WORK ORDER NON-CONFORMANCE / UPDATE

DESIGN <i>CP</i>	DRAWN BY <i>CP</i>	DART AEROSPACE LTD HAWKESBURY, ONTARIO, CANADA	
CHECKED <i>#</i>	APPROVED <i>#</i>	DRAWING NO. D3016	REV. A SHEET 1 OF 3
DATE 01.05.18		TITLE SEAT FRAME ASSEMBLY	SCALE NTS
A	01.05.18	NEW ISSUE

DRAWING NO. D3016	TITLE SEAT FRAME ASSEMBLY	REV. A	DART AEROSPACE LTD ENGINEERING ORDER	D.E.O. NO. D3016-A-1	SHEET NO. SHEET 1 OF 1	SCALE NTS
DRAWN <i>1</i>	CHECKED <i>UP</i>	MFG. APPR. <i>RE</i>	APPROVED <i>WAP</i>	DE APPR. <i>#</i>		
DATE 10.01.29	DATE 10.01.29	DATE 10.01.29	DATE 10.01.29	DATE 10.01.29

D3016-11 SADDLE

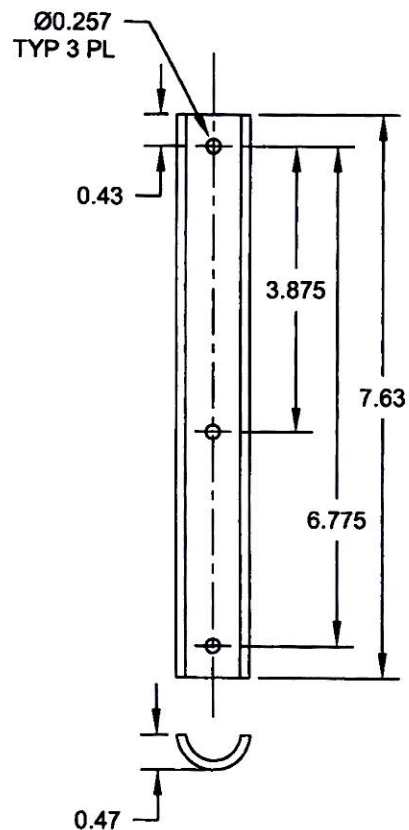
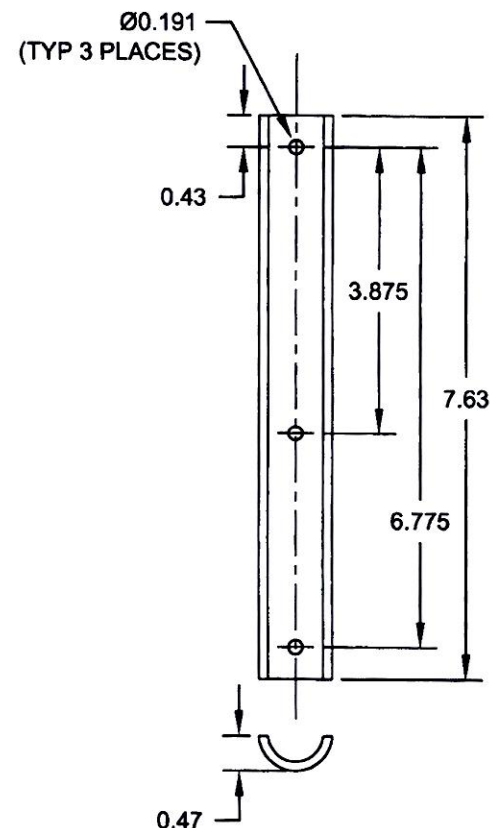
TO REVISE D3016-11 SADDLE'S HOLE SIZES

DETAIL D3016-11 SADDLE (SHEET 3): Ø0.257 TYP 3 PL WAS Ø0.191 (TYP 3 PLACES) AS SHOWN:
